Access Compliance Report

Public Rights-of-Way

(Curb Ramps)

Intersection ID: 32292	Main Street: OLD_ARDREY_KELL_RD	Cross Street: HONEYNUT_DR	Location: SE
ADA ID: 0A62B71E4266	Ramp Type: ParaDiag	Initial Pass/Fail: Fail	Overall Compliance: No
Codes/Mitigation Info/Possible Solution		Field Measurements/Component Compliance	
Severity Score: 21.25

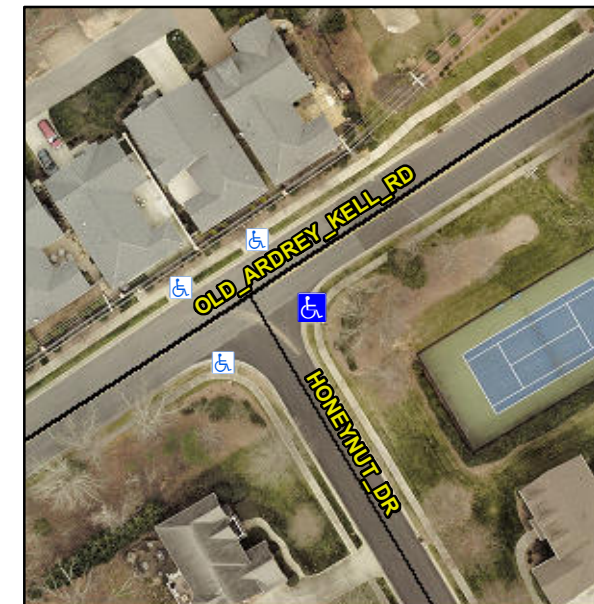
R304.5.1, R304.3.2

Compliance	Description	Data	Compliance	Description	Data
N/A	Ramp Length LT (in)	44.5	N/A	Ramp Length RT (in)	49.0
No	Ramp Width LT (in)	45.0	No	Ramp Width RT (in)	45.5
No	Ramp Slope LT (%)	10.5	Yes	Ramp Slope RT (%)	5.5
Yes	Ramp XSlope LT (%)	0.9	Yes	Ramp XSlope RT (%)	0.7
N/A	Landing Length (in)	N/A	N/A	DWS Provided?	N/A
N/A	Landing Width (in)	N/A	N/A	DWS Contrast?	N/A
N/A	Landing Slope (%)	N/A	N/A	DWS Length (in)	N/A
N/A	Landing X Slope (%)	N/A	N/A	DWS Full Width?	N/A
N/A	Landing Curb? (Y/N)	N/A	N/A	DWS Offset (in)	N/A
N/A	Shared Landing?	N/A			
N/A	Gutter Ponding?	N/A	N/A	Gutter Slope (%)	N/A
N/A	Gutter Lip Ht (in)	N/A	N/A	Gutter X Slope (%)	N/A
N/A	Painted X Walk1?	No	N/A	Painted X Walk2?	No
	X Walk 1 Direction	To NW		X Walk 2 Direction	To SW
N/A	X Walk 1 Width (in)	N/A	N/A	X Walk 2 Width (in)	N/A
	X Walk 1 Slope (%)	9.7		X Walk 2 Slope (%)	0.2
	X Walk 1 X Slope (%)	0.3		X Walk 2 X Slope (%)	9.2
N/A	Ramp inside XWalk1?	N/A	N/A	Ramp inside XWalk2?	N/A

Road Slope (%)	6.4	N/A	Clear Space?	N/A
	Road X Slope (%)	2.9	N/A	Clear Space to XWalk (in)	N/A
N/A	Any Obstructions?	N/A	N/A	Storm Grate/Utility Hazard?	N/A
	Obstruction Type			Storm Grate/Utility Type	
		N/A			N/A
			Yes	Surface Condition? (G/P)	Good
			N/A	Curb Slope (%)	7.6

Remove & Replace Curb Ramp With Two New Directional Ramps or Equivalent.
